# Subregional RTEP Committee – Western FirstEnergy Supplemental Projects

October 18, 2024

ATSI Transmission Zone M-3 Process Gilchrist – Star 69 kV Line

s3359.1: Originally presented in 10/14/2022 and 10/18/2024 SRRTEP Western meetings Changes are marked in red

### ATSI Transmission Zone M-3 Process Gilchrist – Star 69 kV Line

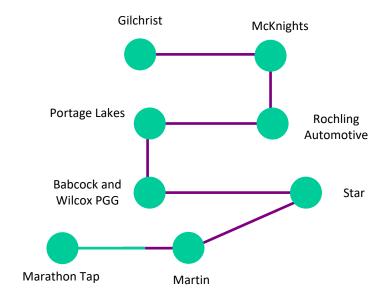
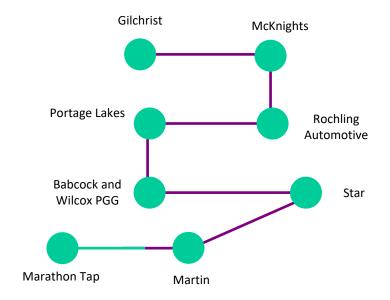
Estimated Project Cost: \$97.7 M \$71.7 M
